Access Compliance Report

Public Rights-of-Way

Intersection ID: 43659	Main Street: TAYLOR RIDGE LN	Cross Street: STARR NEELY RD	Location: NE
ADA ID: 7208966C47E7	Ramp Type: PerpDiag	Initial Pass/Fail: Fail	Overall Compliance: No
Severity Score: 22.5			
Codes/Mitigation Info/Possible Solution		Field Measurements/Component Compliance

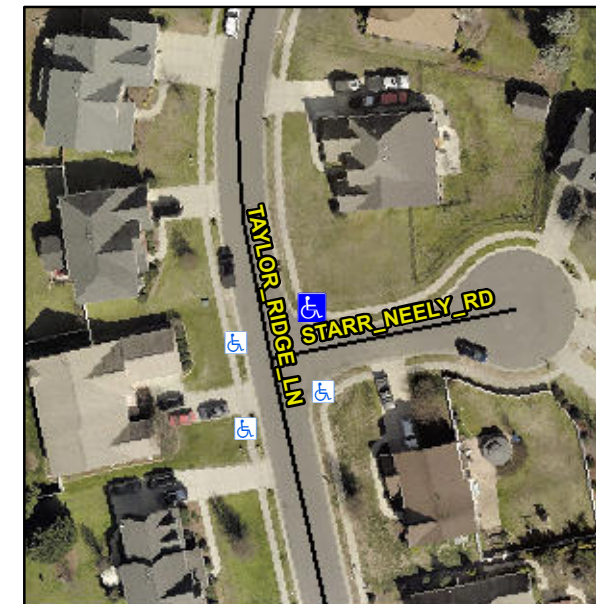
Not Found, R304.5.1, R304.2.2, R304.5.3

Compliance	Description	Data	Compliance	Description	Data
N/A	Ramp Length (in)	48.0	No	Ramp Slope (%)	8.9
No	Ramp Width (in)	38.0	No	Ramp XSlope (%)	4.4
N/A	Flare Type LT	N/A	N/A	Flare Type RT	N/A
N/A	Flare Slope LT (%)	N/A	N/A	Flare Slope RT (%)	N/A
N/A	Flare Traversable LT?	N/A	N/A	Flare Traversable RT?	N/A
N/A	Landing Length (in)	N/A	N/A	DWS Provided?	N/A
N/A	Landing Width (in)	N/A	N/A	DWS Contrast?	N/A
N/A	Landing Slope (%)	N/A	N/A	DWS Length (in)	N/A
N/A	Landing X Slope (%)	N/A	N/A	DWS Full Width?	N/A
N/A	Landing Curb? (Y/N)	N/A	N/A	DWS Offset (in)	N/A
N/A	Shared Landing?	N/A			
N/A	Gutter Ponding?	N/A	N/A	Gutter Slope (%)	N/A
N/A	Gutter Lip Ht (in)	N/A	N/A	Gutter X Slope (%)	N/A
N/A	Painted X Walk1?	No	N/A	Painted X Walk2?	No
	X Walk 1 Direction	To W		X Walk 2 Direction	To S
N/A	X Walk 1 Width (in)	N/A	N/A	X Walk 2 Width (in)	N/A
	X Walk 1 Slope (%)	3.8		X Walk 2 Slope (%)	1.9
	X Walk 1 X Slope (%)	1.3		X Walk 2 X Slope (%)	1.6

Remove & Replace Curb Ramp With Two New Directional Ramps or Equivalent.
